Service Bulletin 578

Issue 1 - 05.2020

Subject: 30 Amp Fuse				
Bulletin Number	Models Affected	VIN Range		Markets Affected
578	Tiger 900	From 978905	To AB7717	All Markets except Brazil and India
	Tiger 900 GT		To AB8337	Brazil and India Markets Only
	Tiger 900 GT Pro			
	Tiger 900 Rally			
	Tiger 900 Rally Pro			
	Tiger 900 GT- LRH (Low Ride Height)

1. Cover

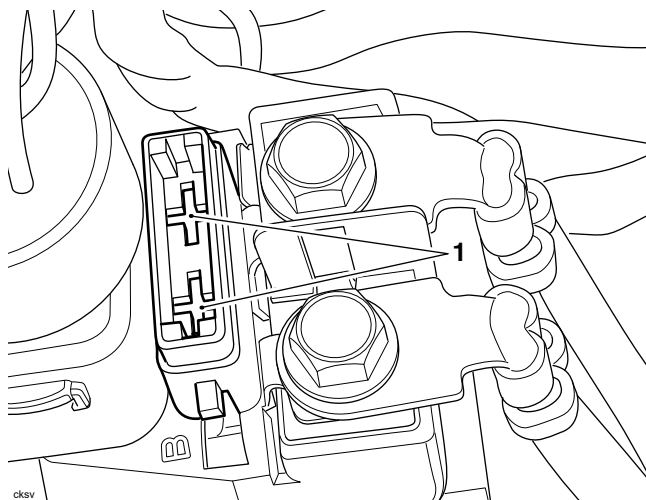
1. Remove the following components as described in the Service Manual:
 - Rider's seat
 - Battery
2. Detach the starter motor solenoid from the base of the rear mudguard.
3. Remove the cover from the starter motor solenoid.

1. Fuse holder

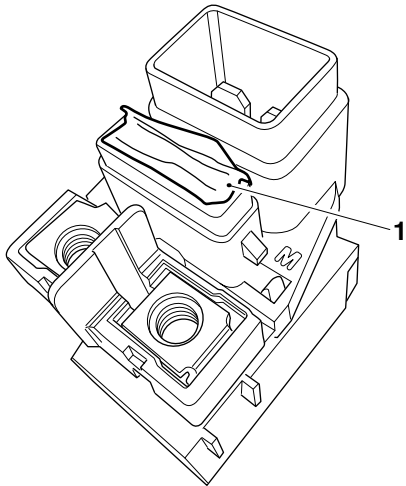
4. Remove the 30A fuse.
5. Check the fuse and the fuse holder for damage and the fuse holder for grease.

6. Clean out the fuse holder and fill the fuse holder with grease (Castrol LCX 222 or equivalent).
